TITLE POSSIBLE DESIGN MODIFICATIONS OF ITER FUEL CYCLE

AUTHOR(S) D. K. Sze and P. A. Finn, Argonne National Laboratory

POSSIBLE DESIGN MODIFICATIONS OF ITER FUEL CYCLE*

Figure 1. ITER isotope separation system process flow diagram.

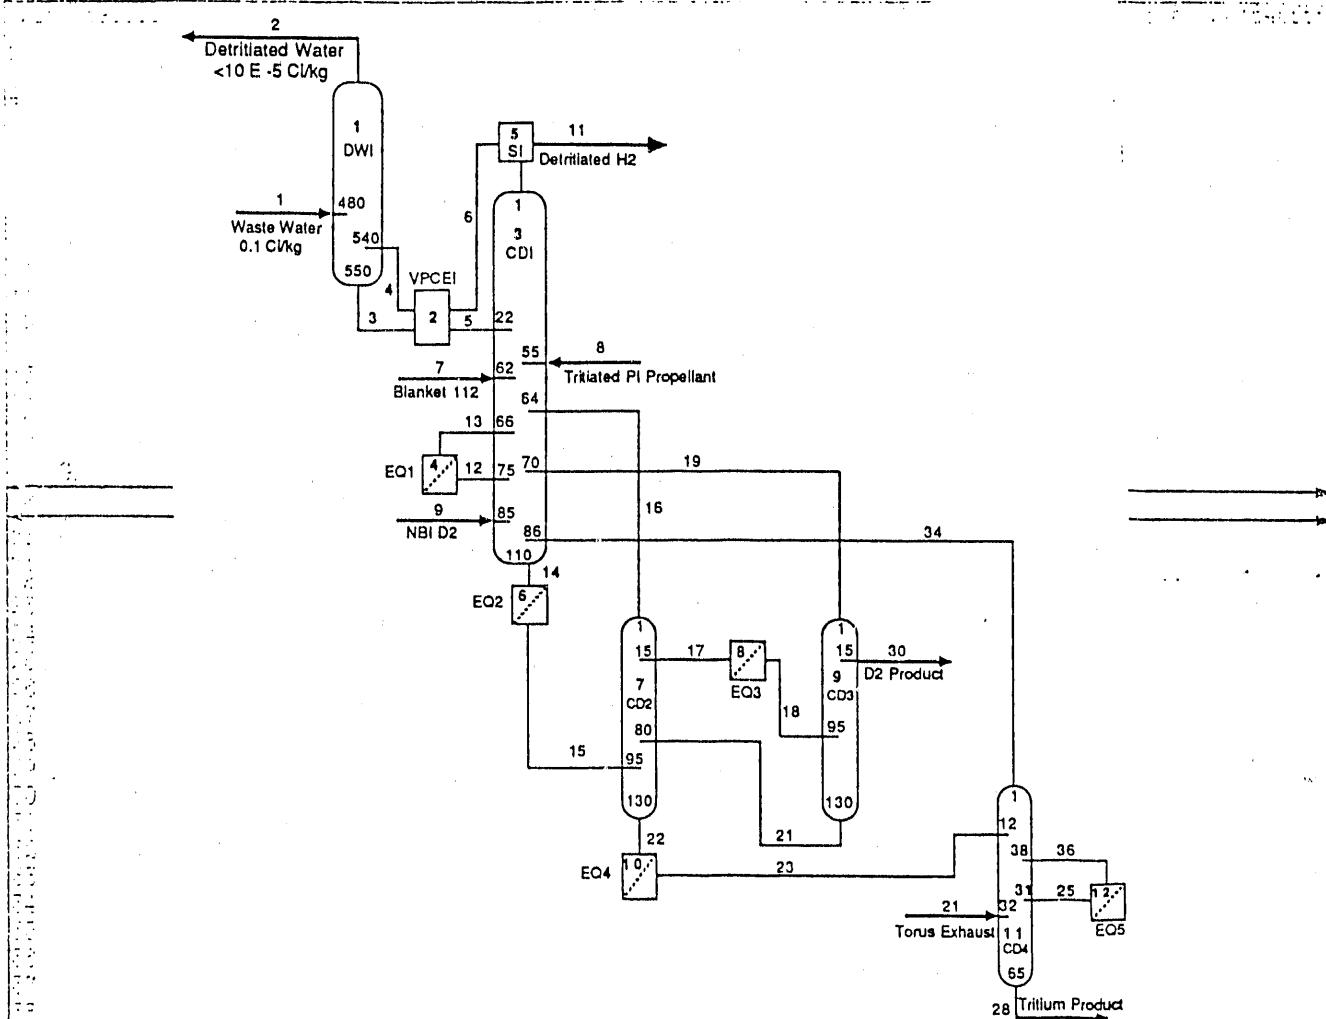
As shown in Table 1 and Fig. 1, there is a large waste water throughput of 4000 mole/h, with a tritium concentration of 0.1 Ci/kg. The source of this waste water is summarized in Table 2. The unit in the ITER document is kg/d. The column 2 changes the unit to mole/h, to be consistent to the figures in Table 1. It can be seen that there is a factor of 2 difference in the waste water throughput in Table 1 and Table 2. Since the waste water throughput is defined by Table 1, 8000 mole/h will be the figure to use in this paper. The coolant water receives tritium by permeation. The coolant detritiation requirements are not well defined, as can be seen on Table 2. It does not appear to be included in the fuel processing system design, as can be seen on Fig. 1.

A careful review of the ITER fuel processing system uncovered the following concerns:

1. There is no clear differentiation between the internal recirculation stream (the streams to be reused) and the external recirculation stream (the streams to be released to the environment). The best example of this is the waste water streams as shown in Table 2. The waste water from the post-accident, emergency cleanup are most likely from coolant loop. A cleanup system will be required to remove the impurities picked up during the accident. The water can be returned to the coolant loop without detritiation (so-called internal recirculation). The accident most likely will occur irregularly and infrequently. Therefore, this water stream cannot be used as the coolant stream tritium control.

Table 3 summarizes different scenarios of the product specifications. The scenario 5 is recommended here. The reasons that the particular product specifications are suggested are:

- H in D+T. A .1% of protein in DT feed to the plasma will have no impact on plasma performance. The plasma impurity will be dominated by He.
- T in H. A 1 to .1% impurity in the hydrogen propellant is acceptable.⁵ Therefore, a conservative composition of .1% is selected.
- T in D. A 1 to .1% of tritium impurity in the neutral beam is acceptable.⁴ Therefore, a .1% tritium concentration is used.

d. D/T. Since plasma is operated in 50/50 DT mixture, there is no need to separate D and T. The only function of the CD will be to remove protium generated by the D-D reaction.

e. HTO in H₂O. The tritium release rate is set at .1 Ci/d. The 1.2×10^{-10} concentration is consistent to this release rate.
